**Agenda item:** AH99

**Source:** Ericsson

**Title:** CR 25.212-088r1: Clarifications to TS 25.212

**Figure 10: Channel coding of split mode TFCI information bits**

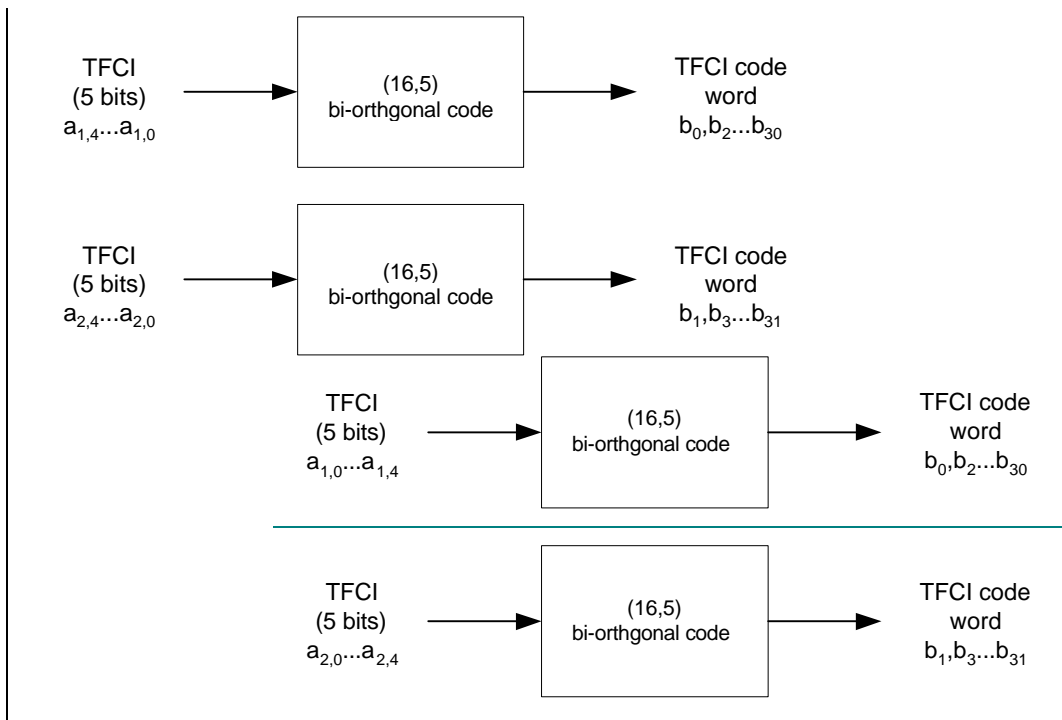
- 4.2.7 Editorial change: Remove the underlined style of  $Np_{i,l}^{TTI,m}$ .
- 4.2.7.2.1.1: Correction of the section title. Compressed mode by higher layer scheduling is only defined for flexible positions of TrCHs.
- 4.2.9.2: Change the sentence about 2<sup>nd</sup> DTX insertion for compressed frames using puncturing and fixed positions. There is no need to insert – due to compressed mode – 2<sup>nd</sup> DTX indication, since p-bits are used.
- 4.2.10: Remove index  $i$  from Physical channel segmentation description. Physical channel segmentation is done after TrCH multiplexing, so there is no need to use the index  $i$  which is normally indexing the TrCH number.
- 4.3.3 and 4.3.4: Clarify the order of TFCI encoding. LSBs should be depicted on the right hand side in the figures, as usually done in binary notations.
